Department of Infrastructure, Local Government and Planning

Our reference: SDA-0117-036553 Council reference: MCUI 2016/1591 (D#782952)

Concurrence agency response—with conditions

Material change of use for a caravan park on land situated at Captain Cook Highway, Port Douglas and described as Lot 45 on SR835. (Given under section 285 of the *Sustainable Planning Act 2009*)

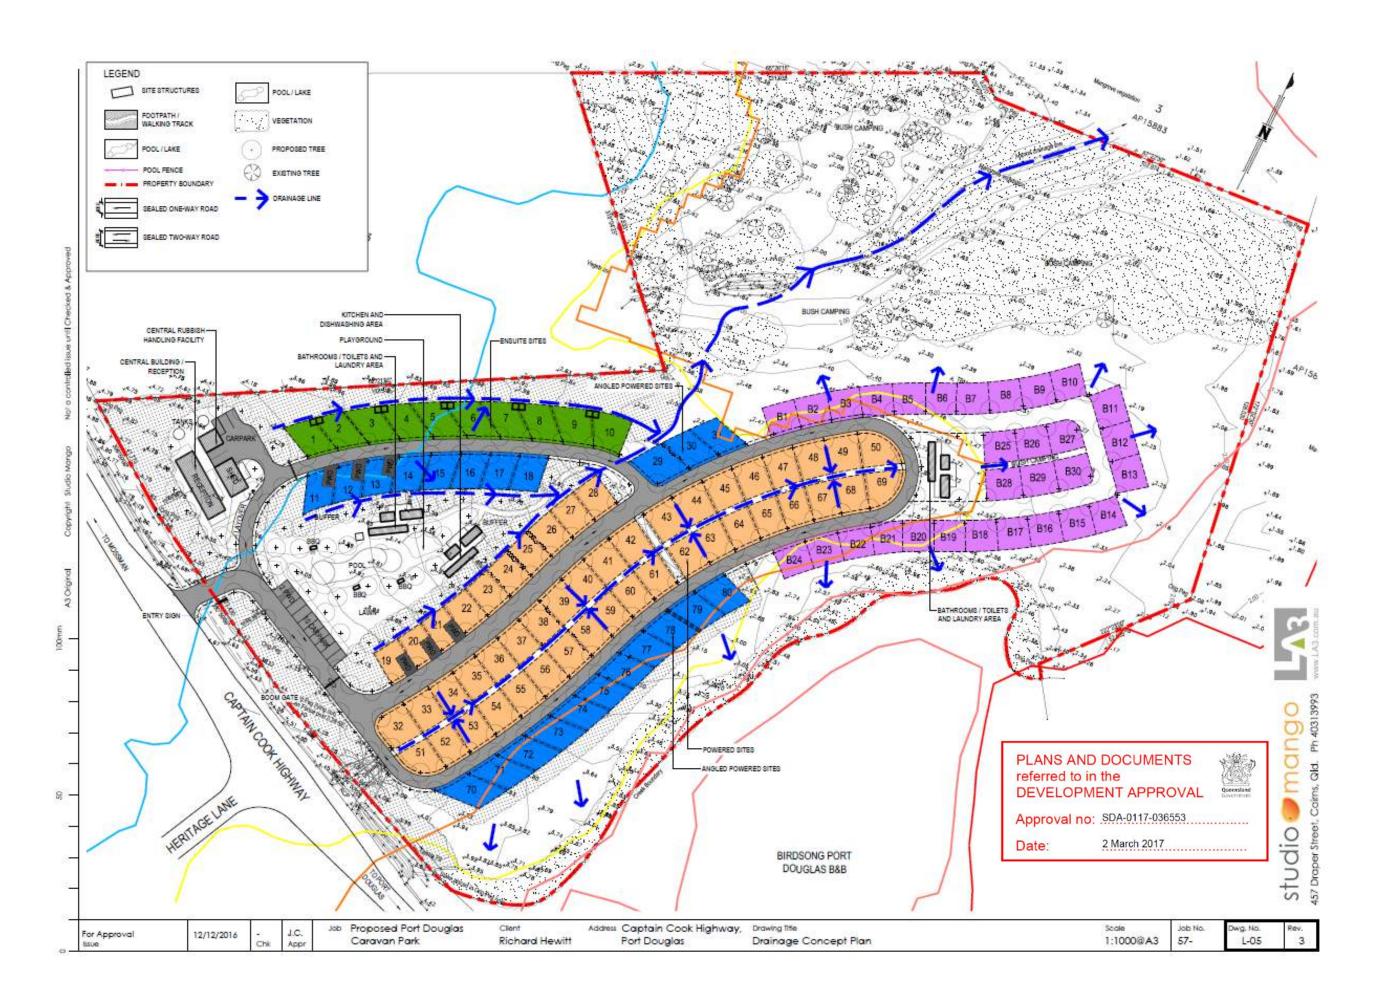
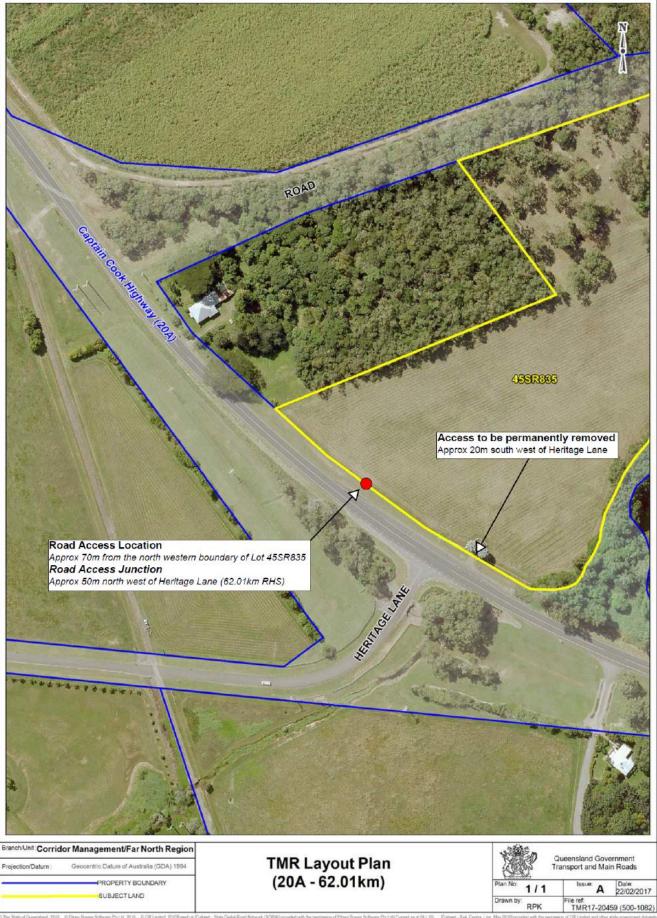
Vehi	cular access to the state-controlled road	
2	The road access location is to be located generally in accordance with TMR Layout Plan (20A - 62.01km) prepared by Queensland Government Transport and Main Roads, dated 22/02/2017, Reference TMR17-20459 (500-1082), Issue A.	Prior to the commencement of use and to be maintained at all times.
Road	l works on a state-controlled road	
3	 (a) Roadworks comprising of a Channelized Right-turn (CHR) treatment, a Rural Auxiliary Left-turn (AUL) treatment and Category V5 Lighting must be provided at the road access location. (b) The roadworks must be designed and constructed in accordance with: Austroads Guide to Road Design: Part 4A Unsignalised and Signalised Intersections, dated 2010. Figure 7.7: Channelised right-turn (CHR) on a two-lane rural road, and Figure 8.4: Auxiliary left-turn treatment (AUL) on a rural road. 	Prior to the commencement of use.
